SUNDRY NOTICES AND REPORTS ON WELLS
Do not use this form for proposals to drill or to re-enter an abandoned well. Use form 3160-3 (APD) for such proposals.

BP requests to P&A the subject well.

GCU #186

Re: Permanent Abandonment
Well: Gallegos Canyon Unit 186

GCU #186
Proposed P&A
Basin Dakota

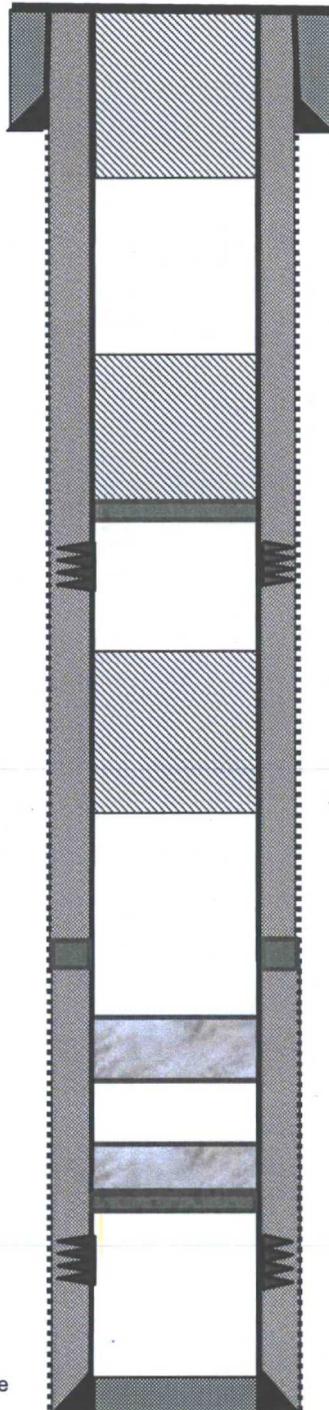
4. **NOTE: BLM requires a CBL log to be run on all wells where the cement did not circulate to surface or a CBL log was not previously run. This procedure is prepared with the understanding that it may be modified based on the TOC from the CBL.**

Low concentrations of H₂S (12 ppm - <100 ppm GSV) have been reported in wells within a 1 mile radius of this location.

You are also required to place cement excesses per 4.2 and 4.4 of the attached General Requirements.

5. **Plug #1 (Mesaverde and Chacra tops, 3021' – 2250')**: Mix and pump 75 sxs Class G cement (extra cement due to open PC perforations) and spot an underbalanced plug inside casing to cover the Mesaverde and Chacra tops. PUH and WOC. TIH and tag cement; top off if necessary.

6. **Plug #2 (Pictured Cliffs perforations, top and Fruitland tops, 1388' – 982')**: R/T 4.5" gauge ring or mill to 1388'. RIH and set 4.5" CR at 1388'. Pressure test tubing to 1000#. Attempt to pressure test casing to 800#. If casing does not test then spot or tag subsequent plugs as necessary. Mix and pump 35 sxs Class G cement and spot a balanced plug inside casing to cover through the Pictured Cliffs and Fruitland top. TOH.

7. **Plug #3 (Kirtland and Surface shoe, 405' – 0')**: Attempt to pressure test the bradenhead annulus to 300 PSI; note the volume to load. If the BH annulus holds pressure, then establish circulation out casing valve with water. Mix approximately 35 sxs cement and spot a balanced plug from 405' to surface, circulate good cement out casing valve. TOH and LD tubing. Shut well in and WOC. If the BH annulus does not test, then perforate at the appropriate depth and attempt to circulate cement to surface filling the casing and annulus from the squeeze holes to surface. Shut in well and WOC.
